Serial Number: IFB FQ18064/GG
Date of Issue: April 13, 2018
IFB Due Date: May 23, 2018

May 3, 2018

AMENDMENT NO. 1
TO
INVITATION FOR BIDS
FOR
REHABILITATION OF 6 PARKING GARAGES – LARGO TOWN CENTER (NORTH), LARGO TOWN
CENTER (SOUTH), NEW CARROLTON, VIENNA (NORTH), WEST FALLS CHURCH AND WHITE
FLINT
FQ18064/GG

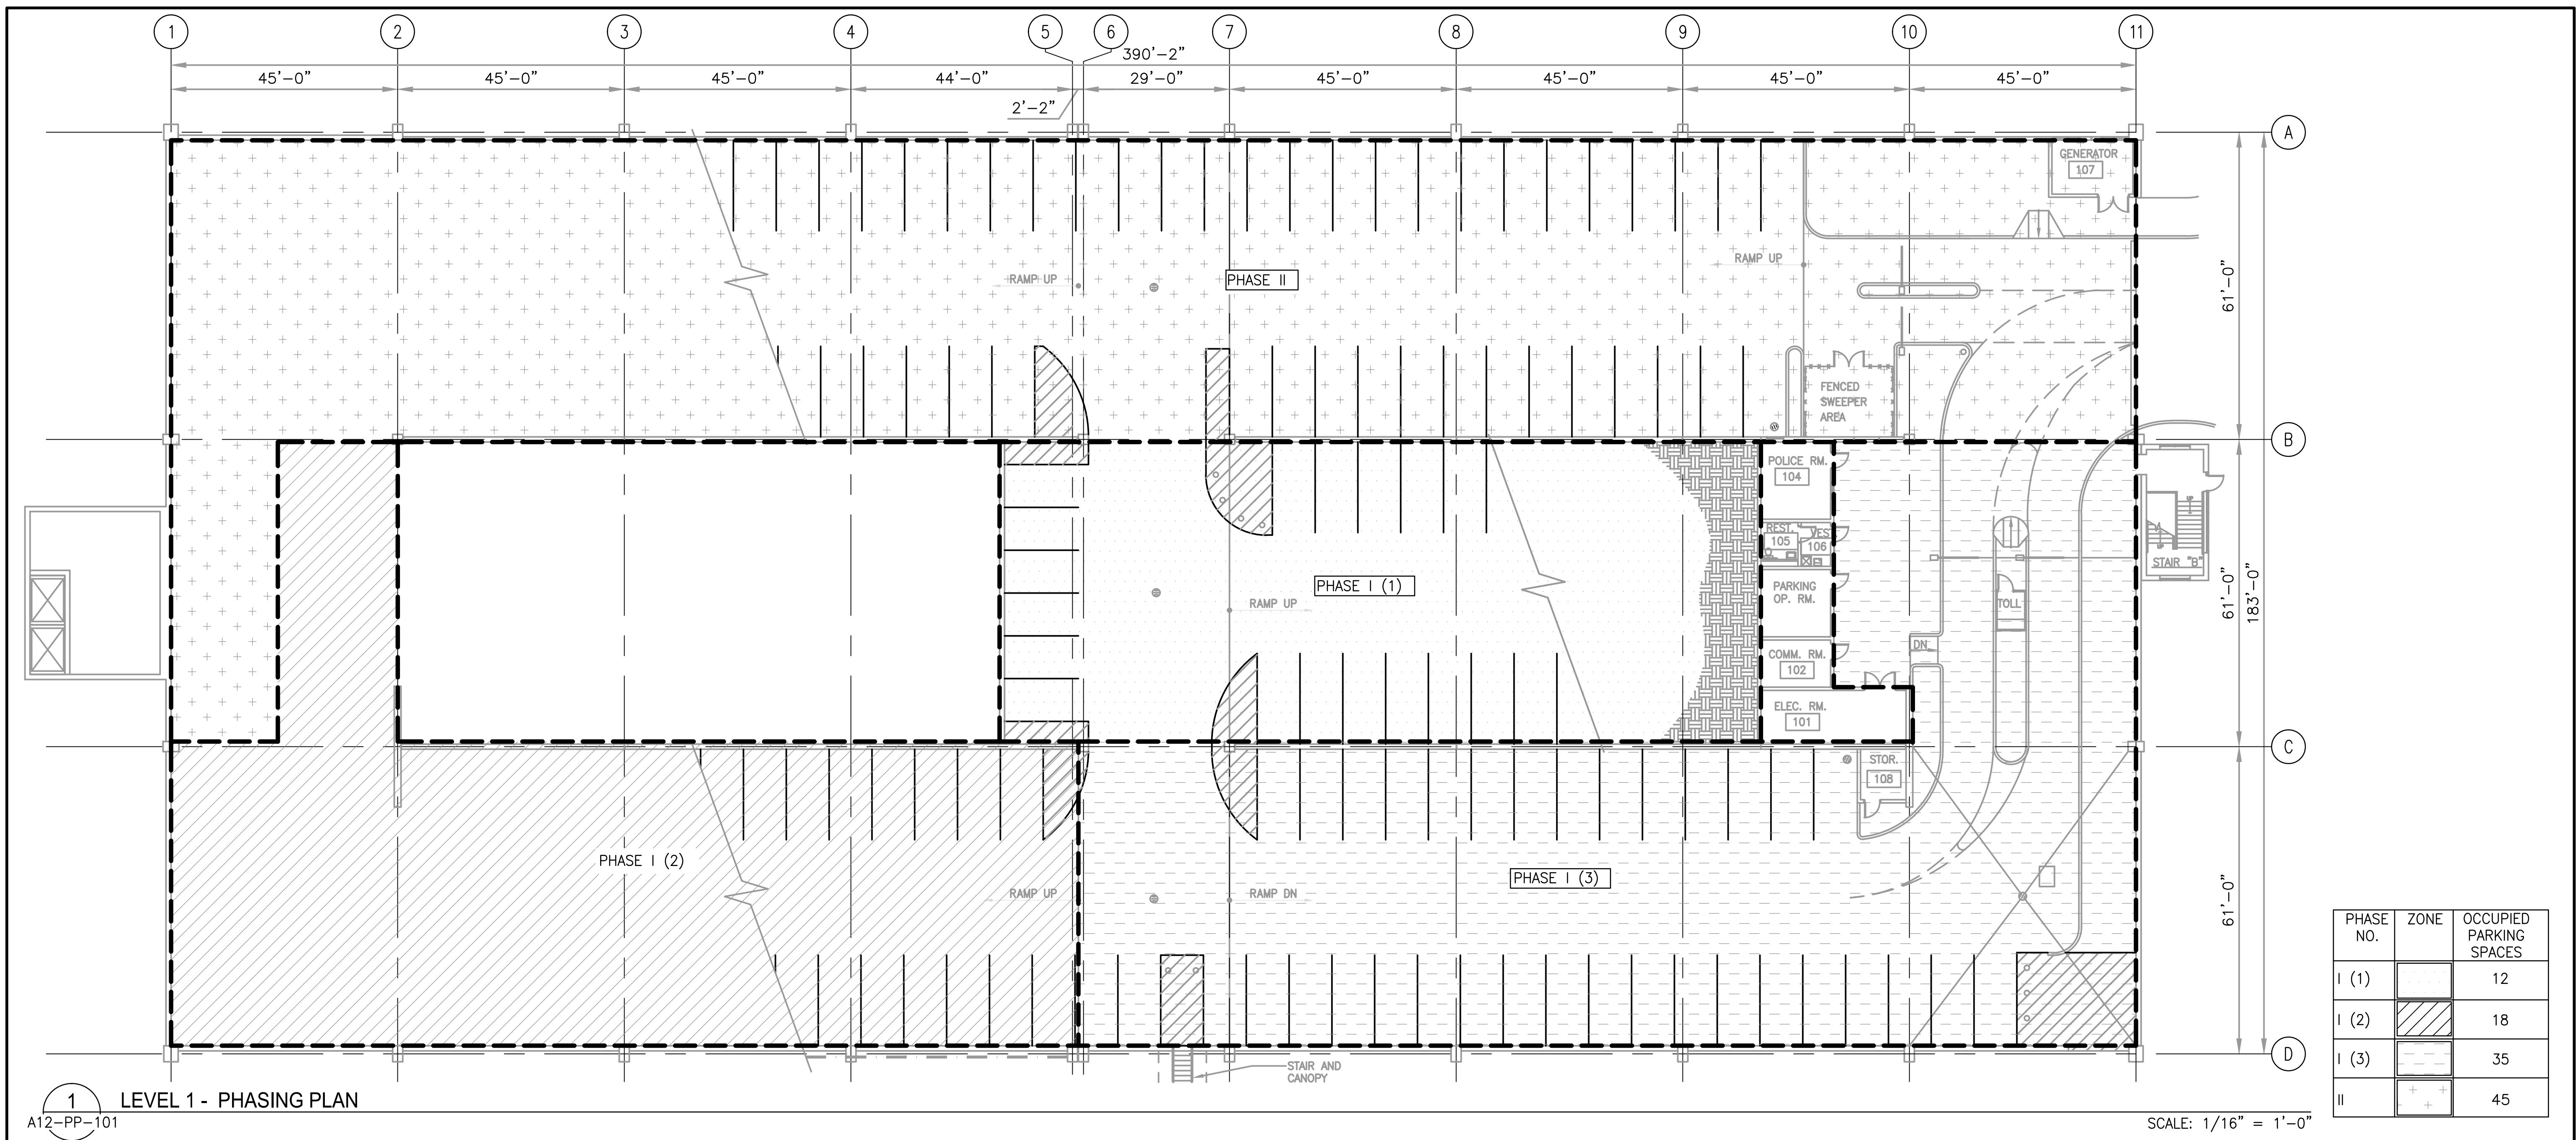
<u>DELETE</u>	<u>SUBSTITUTE</u>	<u>DESCRIPTION</u>
A12-PP-101	A12-PP-101	Revised
D13-PP-101	D13-PP-101	Revised
D13-S-001	D13-S-001	Revised
K06-PP-101	K06-PP-101	Revised
K06-S-001	K06-S-001	Revised
K08-PP-101	K08-PP-101	Revised
K08-S-001	K08-S-001	Revised
K08-S-105	K08-S-105	Revised
